Procedural Paths

Grounds for Appeal

Site Visit

Building Lot Size (how small is too small?)

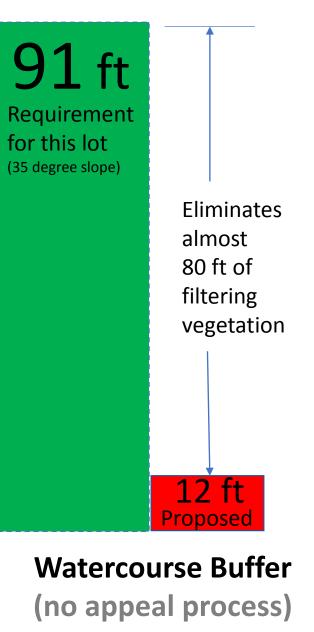
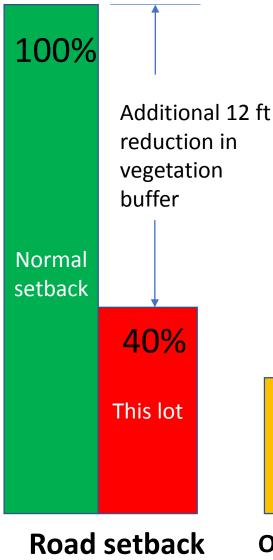
Road setback Ot (proposed)

Height above Mean water level

3.8 m height above mean water level (DATUM):

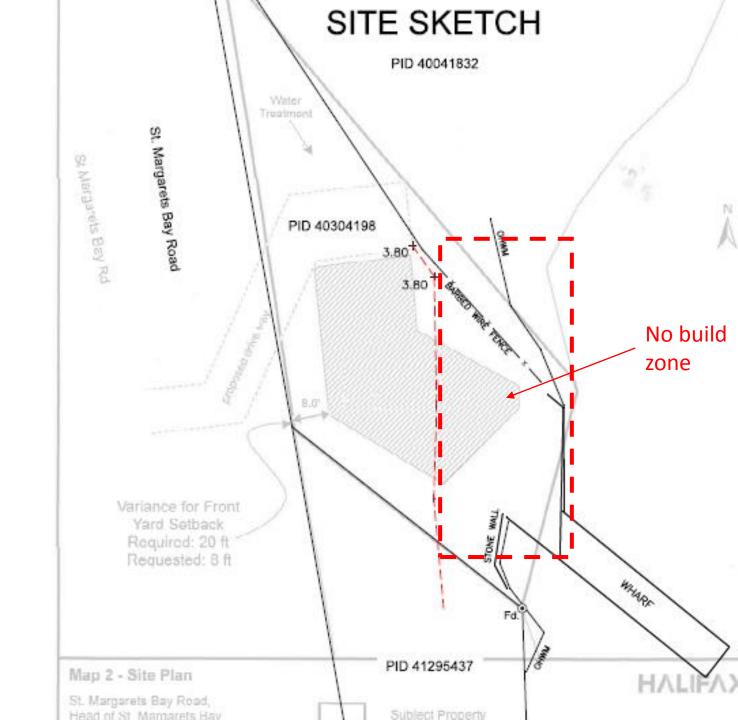
3.8 m height above mean water level (DATUM):

Proposed dwelling implies disturbance and construction of the site located below 3.8M

Development below 3.8 m prohibited

not prudent

Waste Water: Clearances compromised by 66-83%

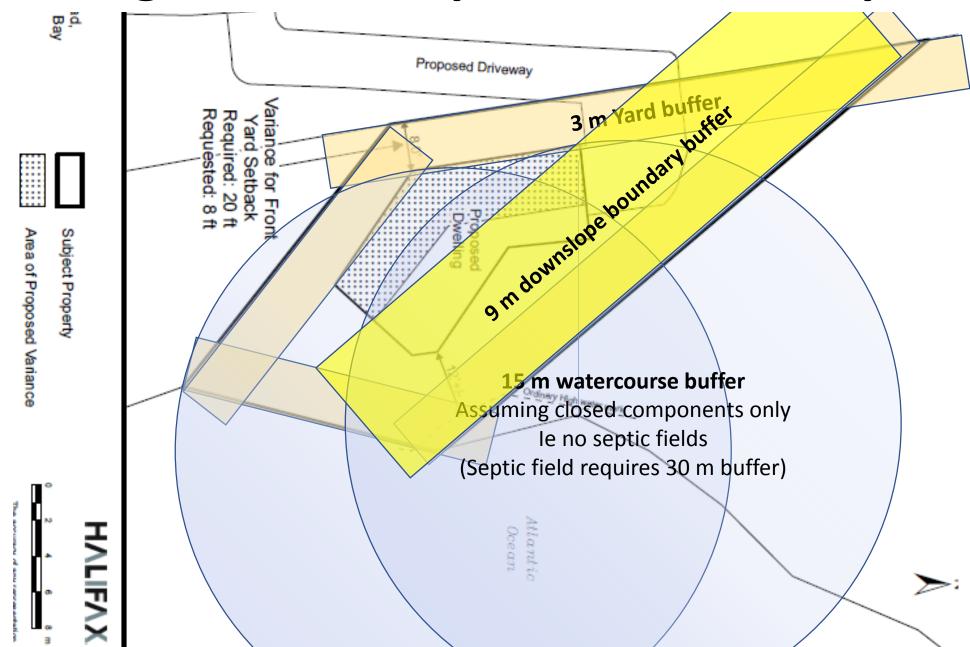
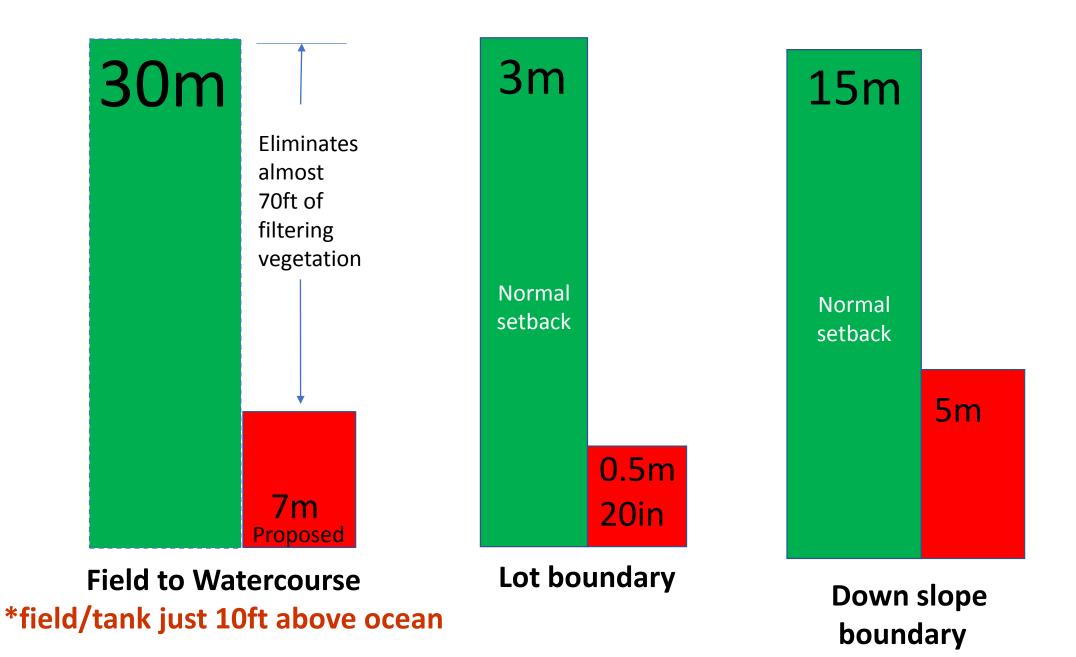
No regulation compliant area for septic
